TECHNICAL SAFETY BULLETIN

Subject: Smart-Steer 2.0 Axle with 702887 Steer Arm

Date: 4/1/2023 **Rev.:**A **No.:** TSBIMT1001

Re.: 702887 Steer Arm Potential Failure

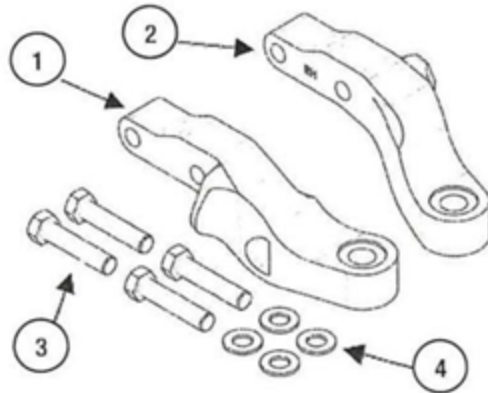
4. Mount new steer arms (Part#703294-01) with supplied hardware.
 - a. Torque to 400 ft. lbs.

Item Number	Quantity	Part Number	Description
1	1	703293-LH	B/O steer arm LH
2	1	703293-RH	B/O steer arm RH
3	4	703100	BOLT 3/4-16UNF 3.25"lg GR8 Yellow Zinc (VM1)
4	4	701810	WASHER FLAT .75" MC2 GR8 (VM1)
Not shown	1	0150425	LOCTITE®, BLUE 242, 0.5ml

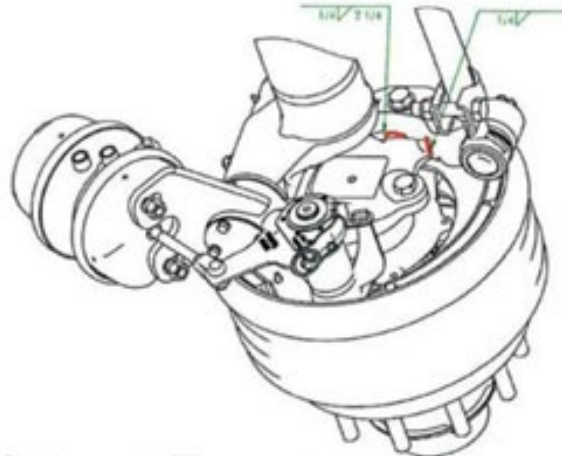
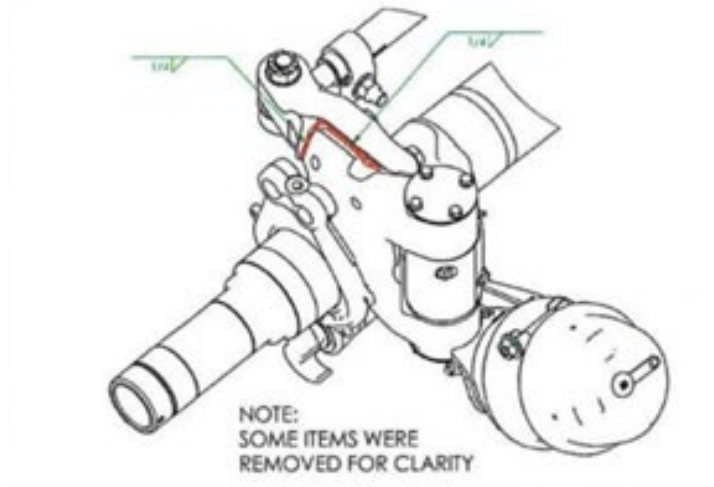
5. Add welds to steer arms as shown.
